Appendix D

Service Point Location Information

Project Description: Project Development and Environment (PD&E) Study
Ludlam Trail Corridor from SW 80th Street to NW 7th Street
Project Number: 403502-15-001-14470619
ETDM Number: 14369
County: Miami-Dade

RE: Ludlam Trail Project
Ludlam Trail from SW 80 St to NW 7 St
Preliminary Plans Review

DRINKING FOUNTAIN, BOTTLE
FILLING, AND PET STATION
4 of 10 STA. 608+89

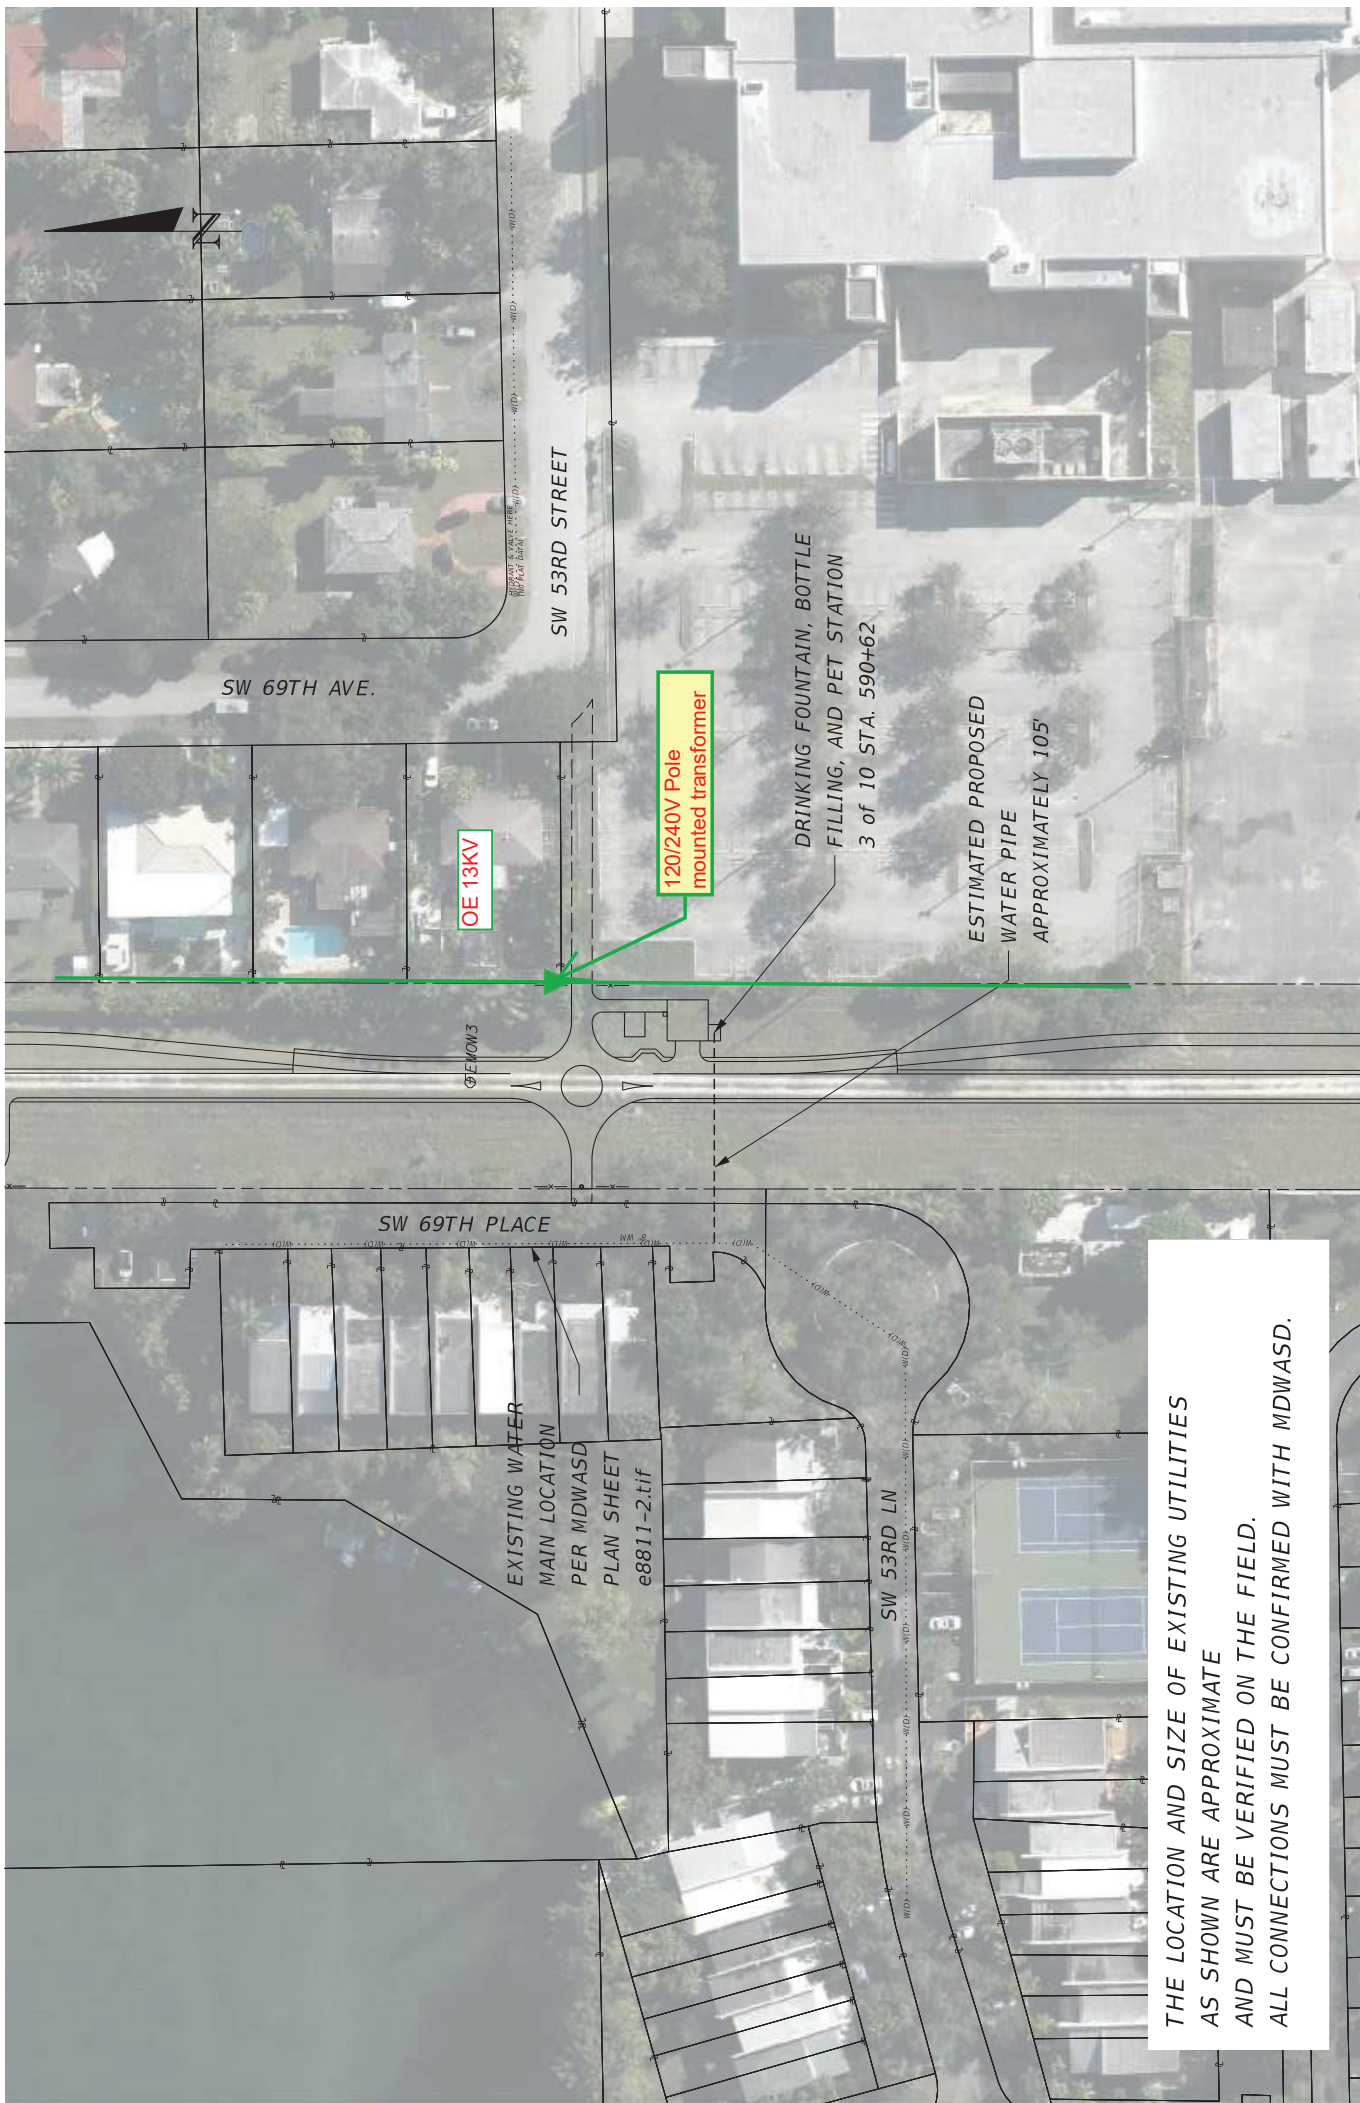
Closest transformer is
on the fourth pole
south of water
fountain.

DRINKING FOUNTAIN, BOTTLE
FILLING, AND PET STATION
9 of 10 STA. 781+92

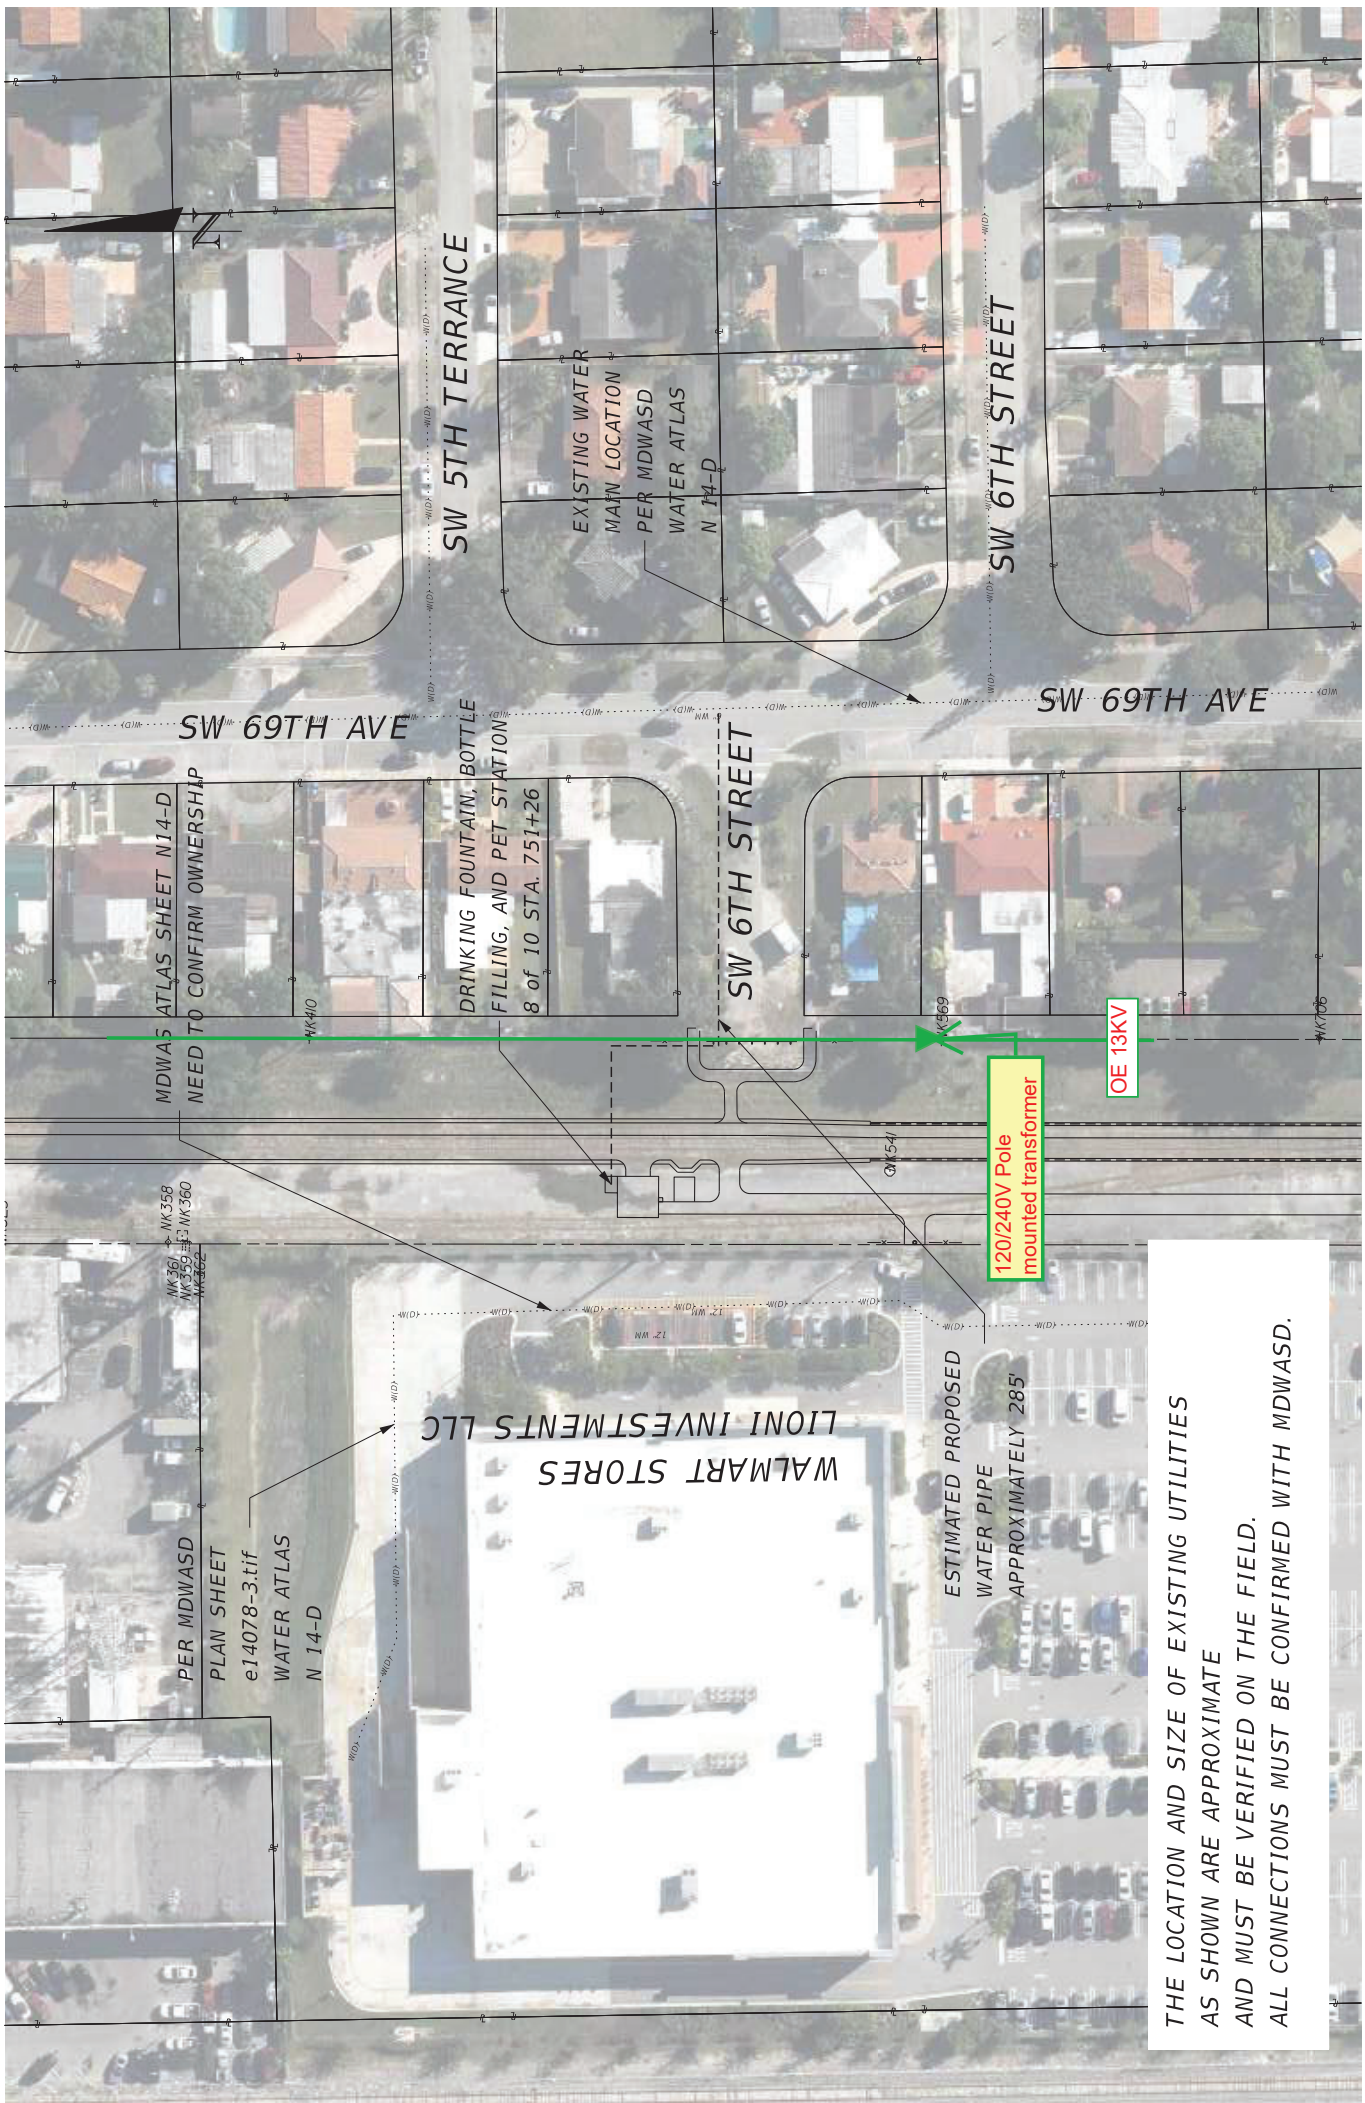
Nearest transformer is
3 poles south of this
location.
